Access Compliance Report

Public Rights-of-Way

Intersection ID: 18459	Main Street: ABBEY_PL	Cross Street: HEDGEMORE DR	Location: SE
ADA ID: 81234A048F4B	Ramp Type: PerpDiag	Initial Pass/Fail: Fail	Overall Compliance: No
Severity Score: 12.5			
Codes/Mitigation Info/Possible Solution		Field Measurements/Component Compliance

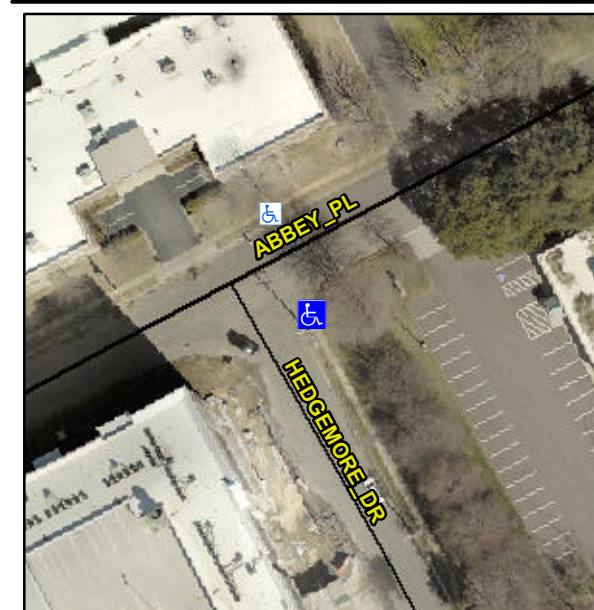
Remove & Replace Curb Ramp With Two New Directional Ramps or Equivalent.

R304.5.3

Compliance	Description	Data	Compliance	Description	Data
N/A	Ramp Length (in)	25.0	Yes	Ramp Slope (%)	5.5
Yes	Ramp Width (in)	48.0	No	Ramp XSlope (%)	6.6
N/A	Flare Type LT	N/A	N/A	Flare Type RT	N/A
N/A	Flare Slope LT (%)	N/A	N/A	Flare Slope RT (%)	N/A
N/A	Flare Traversable LT?	N/A	N/A	Flare Traversable RT?	N/A
N/A	Landing Length (in)	N/A	N/A	DWS Provided?	N/A
N/A	Landing Width (in)	N/A	N/A	DWS Contrast?	N/A
N/A	Landing Slope (%)	N/A	N/A	DWS Length (in)	N/A
N/A	Landing X Slope (%)	N/A	N/A	DWS Full Width?	N/A
N/A	Landing Curb? (Y/N)	N/A	N/A	DWS Offset (in)	N/A
N/A	Shared Landing?	N/A			
N/A	Gutter Ponding?	N/A	N/A	Gutter Slope (%)	N/A
N/A	Gutter Lip Ht (in)	1.5	N/A	Gutter X Slope (%)	N/A
N/A	Painted X Walk1?	No	N/A	Painted X Walk2?	No
	X Walk 1 Direction	To N		X Walk 2 Direction	To W
N/A	X Walk 1 Width (in)	N/A	N/A	X Walk 2 Width (in)	N/A
	X Walk 1 Slope (%)	1.8		X Walk 2 Slope (%)	5.9
	X Walk 1 X Slope (%)	0.9		X Walk 2 X Slope (%)	4.0
